PERMIT MODIFICATION APPROVAL

Re: Permit Modification Approval for API Number 8510134 , Well #: 513758

Re: Modification of well 513761 and 513758
47-085-10134, 10137

STATE OF WEST VIRGINIA
DEPARTMENT OF ENVIRONMENTAL PROTECTION, OFFICE OF OIL AND GAS
W.VA. CODE §22-6A - WELL WORK PERMIT APPLICATION

Well 513758 (OXF163H3)
EQT Production
Oxford
Ritchie **West Virgina**

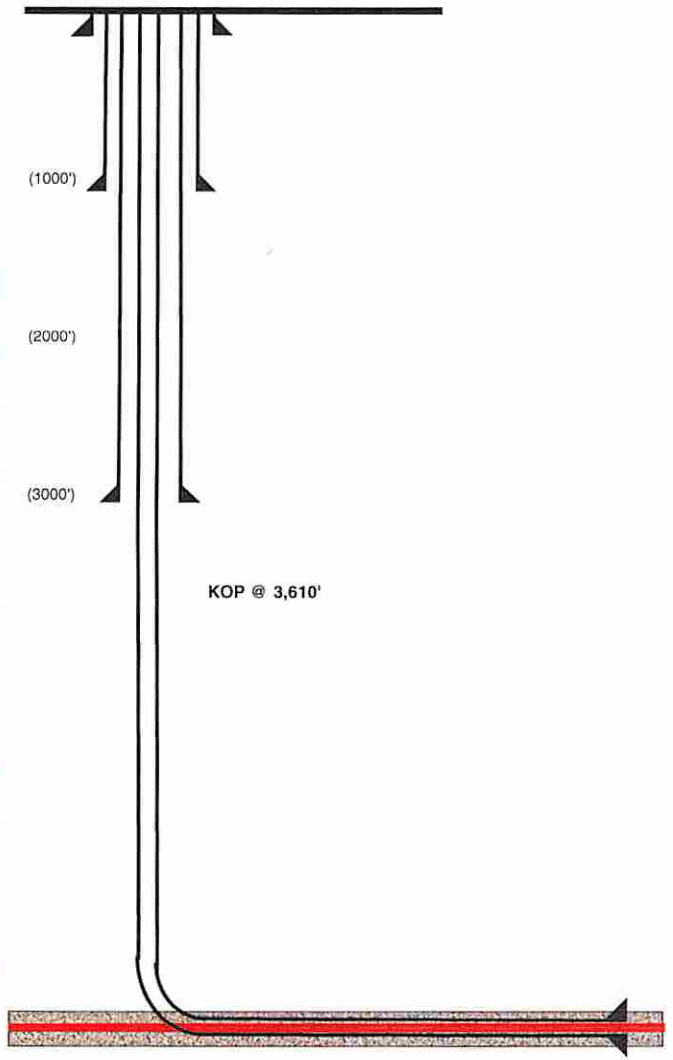
The modification to API # 47-085-10134 is to change the target formation from Marcellus to Geneseo and to change the azimuth, which would change the landing point and bottom hole.

Proposed Well Work:
Drill and complete a new horizontal well in the Geneseo formation.
The vertical drill to go down to an approximate depth of 3610'.
Then kick off the horizontal leg into the Geneseo using a slick water frac.

OPERATORS WELL NO. WV 513758

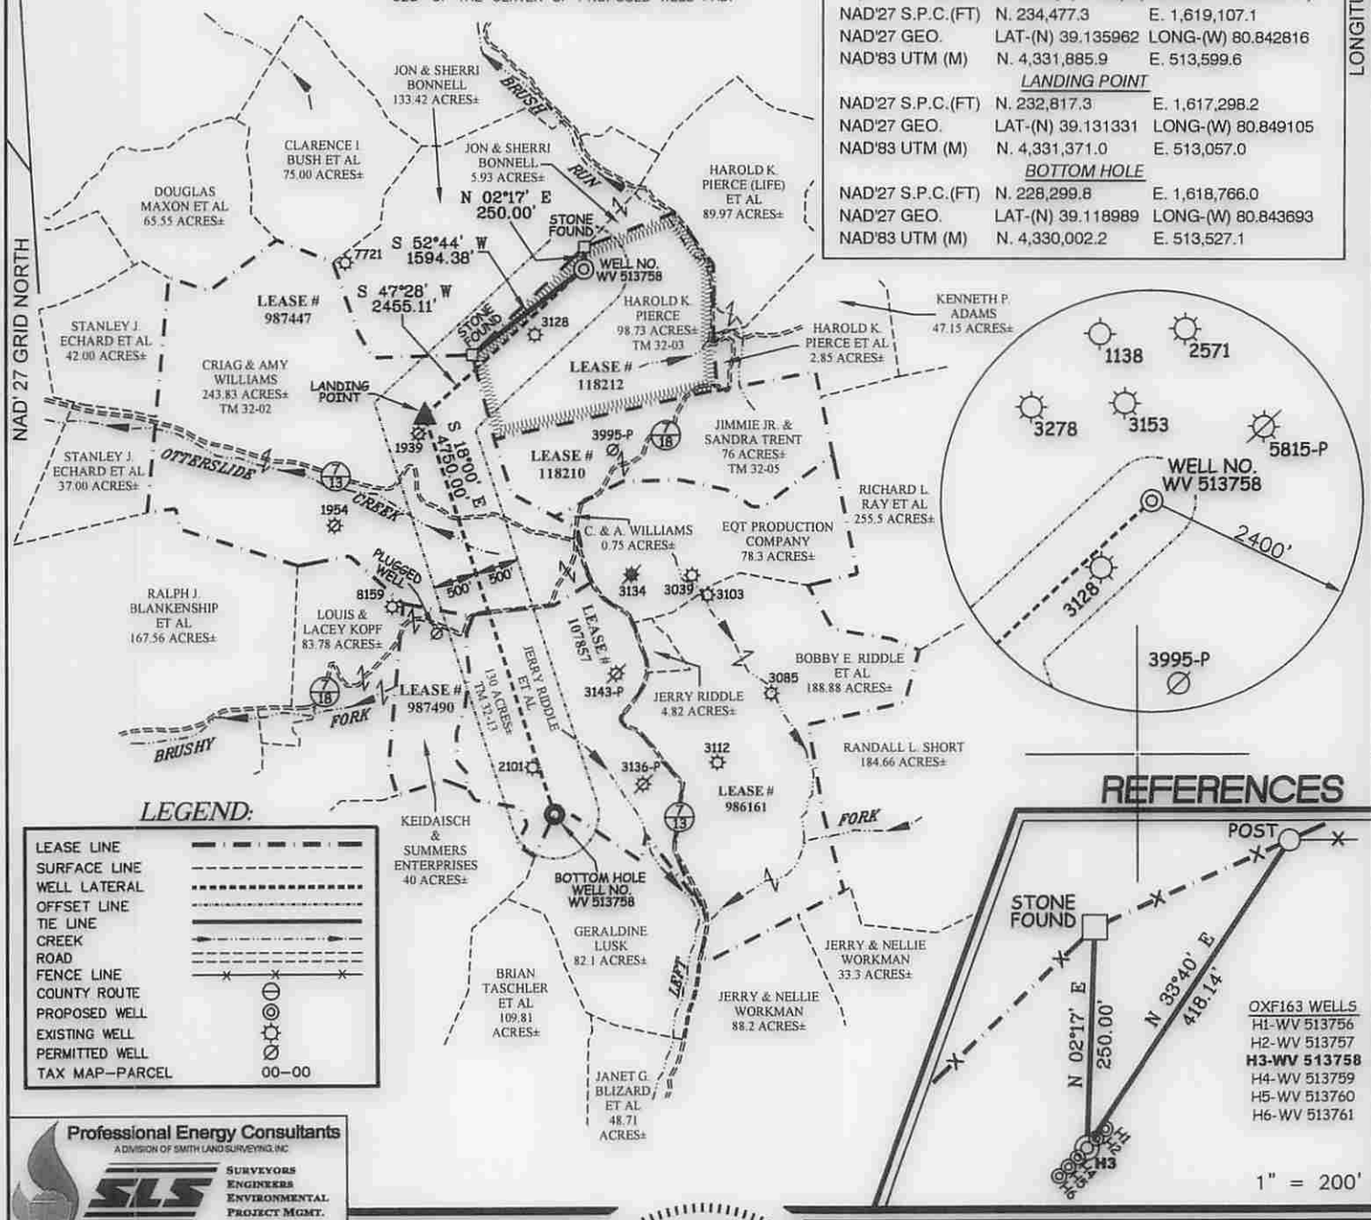
Enclosed is a new WW-6B, schematics, Mylar plat and rec plan for the above API #. EQT would like to request a modification, to API# 47-085-10137, to change the target formation from Geneseo to Marcellus and to change the azimuth, which would change the landing point and bottom hole.

PHYSICAL CHANGE IN WELL (SPECIFY) ____ TARGET FORMATION GENESEO
